ARKANSAS NUCLEAR ONE - UNIT 1

IMPROVED TECHNICAL SPECIFICATIONS SUBMITTAL

VOLUME 6 OF 7

January 28, 2000

Figure 4.18.1 5.5.9-1

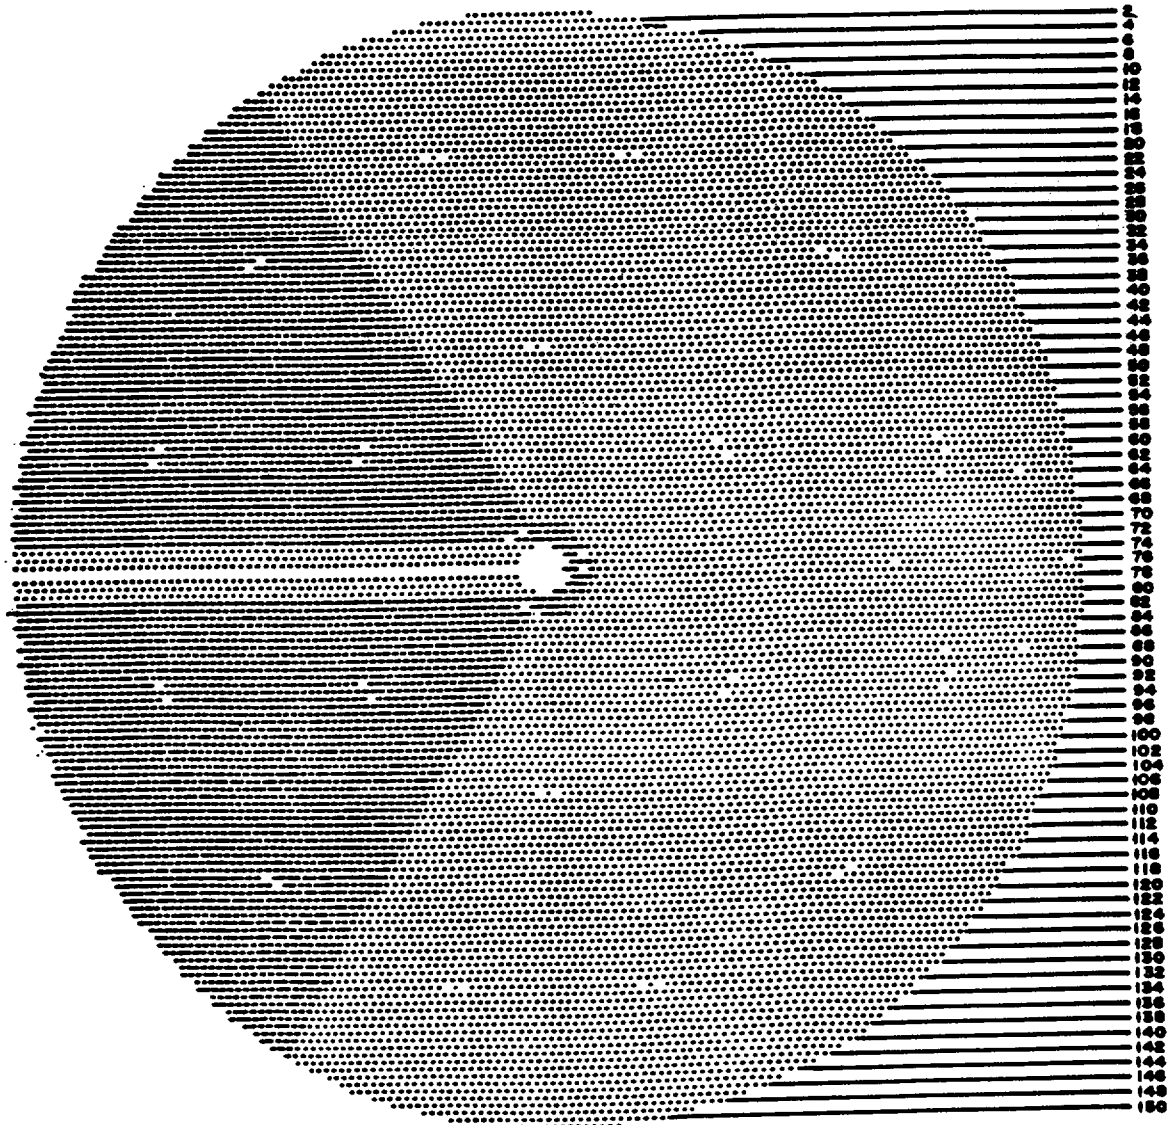
Upper Tube Sheet View of Wedge Shaped Group
(Group A-3) per Specification 4.18.3.a.8 5.5.9.c.1.iii
